**NUMBER:** 22-005-01

Wheel Cover Rattle - 15" Steel Wheels

This bulletin involves the addition of 5 foam pads to each wheel cover.

2000 - 2001 (PL) Neon

**Fig. 1 WHEEL COVER**

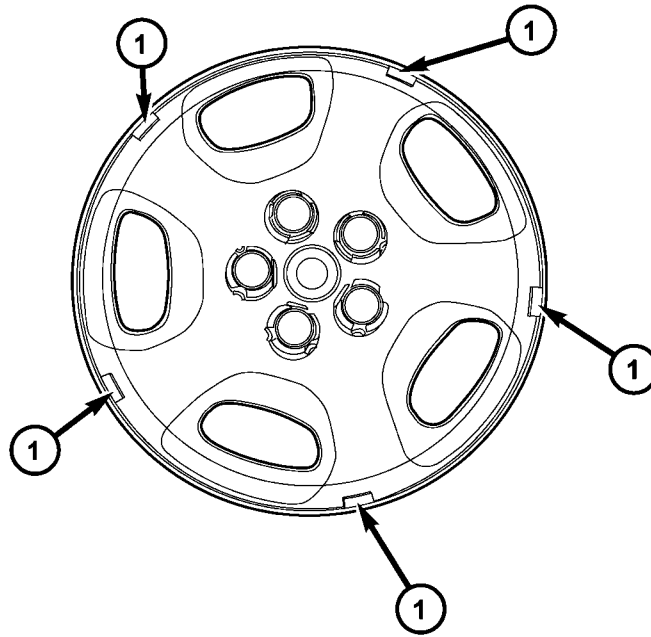
Rattle noise coming from the wheel cover over bumps.

1. Clean the inside surface of the wheel cover where the foam pad will be installed using the Mopar Brake Parts Cleaner.
2. Wipe the cleaner off and allow the wheel cover to dry thoroughly.
3. Remove the backing paper from a foam pad and apply to in the center of one wheel spoke. Repeat the process until all five foam pads have been installed. (Fig. 1)
4. Repeat the procedure for the remaining three wheel covers.
5. Install the four wheel covers onto the vehicle and torque nuts to 25 in.lbs.
